21-COA-0268
155 N. Keats Ave.

Clifton Architectural Review Committee
Public Hearing

Request

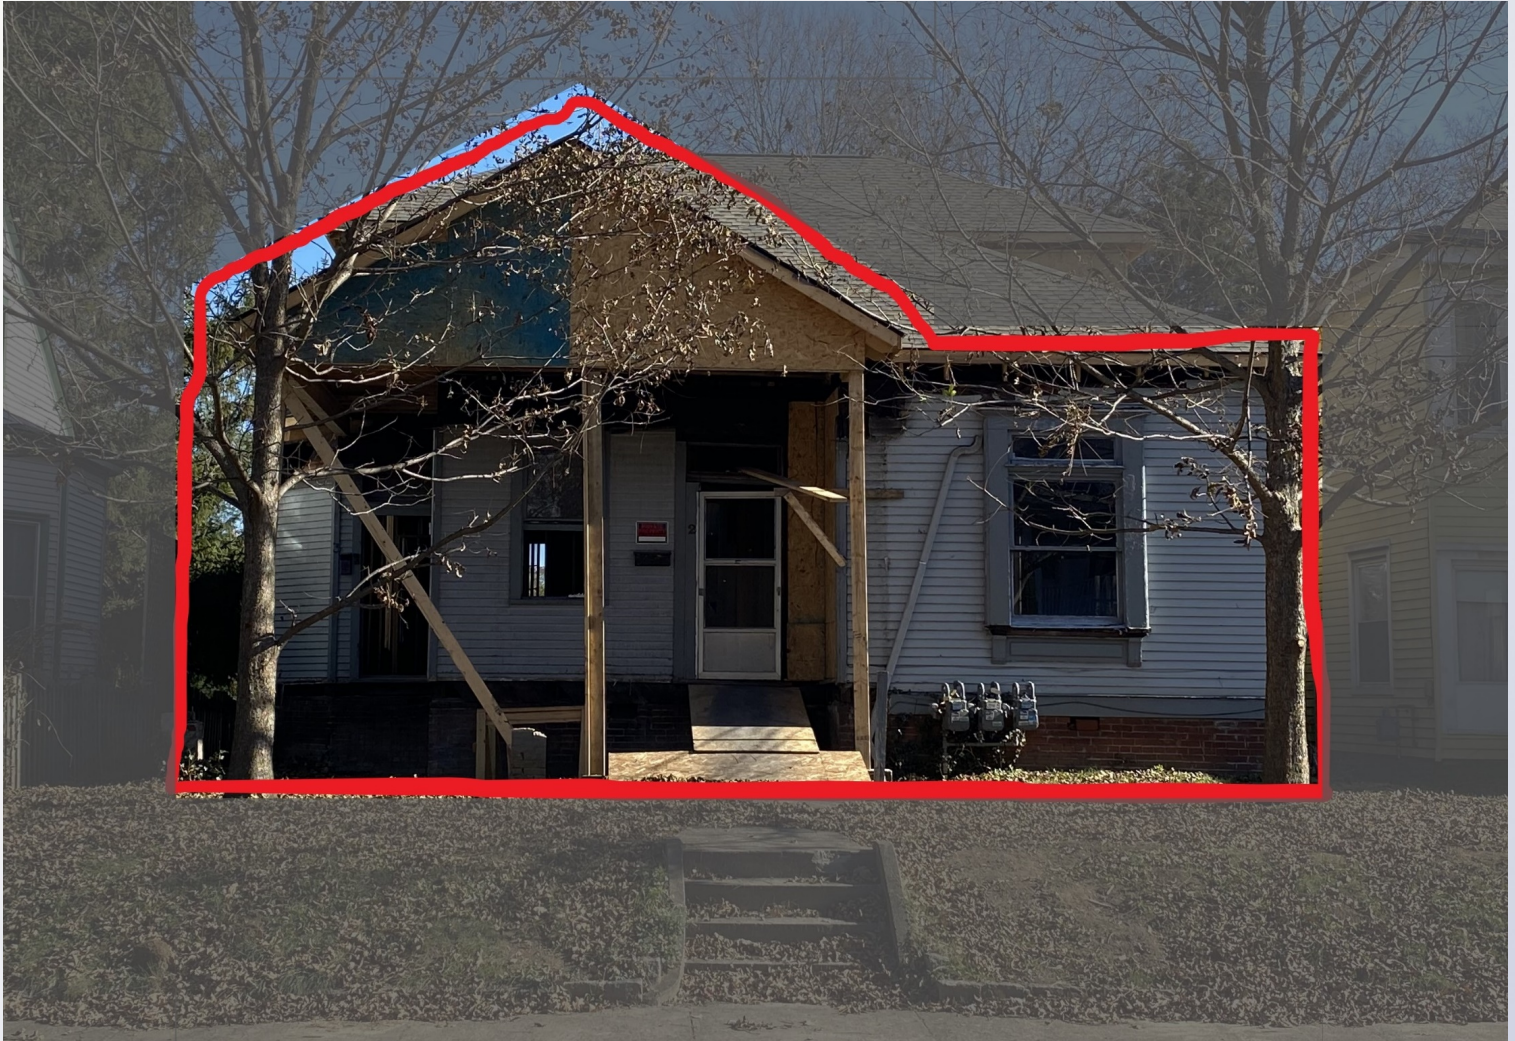
- Roof changes generally meet Clifton design guidelines for **Porch and Roofing**:
 - Previous multi-gabled roof destroyed by fire, was causing water damage;
 - No historic roof/gable fabric remained to retain and had to be rebuilt to secure building
 - New design similar but simplified to address drainage
 - Compatible and in proportion with building; does not overwhelm the façade
 - Delineates new construction from historic
 - Applicant proposes addition of gable end vent, small window, or gable trim to echo previous design details

- Door-to-window conversion generally meets the Clifton design guidelines for **Door and Entrance and Windows**:
 - Not primary entrance
 - Deeply recessed
 - Existing door severely damaged
 - New window to match other front façade replacement windows
 - Opening width and transom to be retained
 - New height to accommodate kitchen cabinets

- Porch design generally meets the Clifton design guidelines for **Porch and Siding and Trim**:
 - Previous porch floor completely removed due to fire damage
 - Previous material and board dimensions unknown
 - Will keep same footprint as previous porch with treated wood
 - Previous columns destroyed
 - Applicant can install new porch supports based on ARC recommended size, delineates new from historic construction, posts located in same locations
- Compatible in design and scale to home and district

- Replacement windows generally meet the Clifton design guidelines for **Windows**:
 - Existing windows are severely deteriorated
 - Replacements to be wood clad, double hung, 1 / 1
 - All transoms to be retained
- Overall project meets applicable design guidelines; thoughtful design to revive property after fire and address drainage; an attempt to retain what can be saved of the structure rather than complete demo and new construction; proportional, compatible, appropriate design for building and district

- Staff recommends the application for a Certificate of Appropriateness be **approved with the following conditions:**
 1. All wood elements shall be opaque painted or stained within 12 months of construction.
 2. Porch floor boards shall be under 2" thick. 3/4" to 1" tongue-and-groove boards are generally appropriate.
 3. The new porch steps shall be reconstructed with in-kind materials (wood). They shall be of the same general scale and dimensions as the original. 5/4" deck boards shall not be used for front porch stair treads.

4. All wood trim shall be retained and repaired/replaced where necessary to match the same dimensions as existing.
5. Any exposed wooden trim shall not be wrapped in vinyl, metal, or siding material and shall remain exposed.
6. The replacement sashes shall fit the historic window openings. Original openings shall not be blocked-in to accommodate stock-sized windows.
7. All transom windows on the front façade shall be retained.
8. The replacement windows shall be double-hung with a 1/1 muntin pattern.

9. If the glass is to be Low-E, the coating shall be clear with no tinting.
10. All other required permits and approvals shall be obtained prior to any work taking place.
11. If the design or materials changes, the applicant shall contact staff for review and approval.
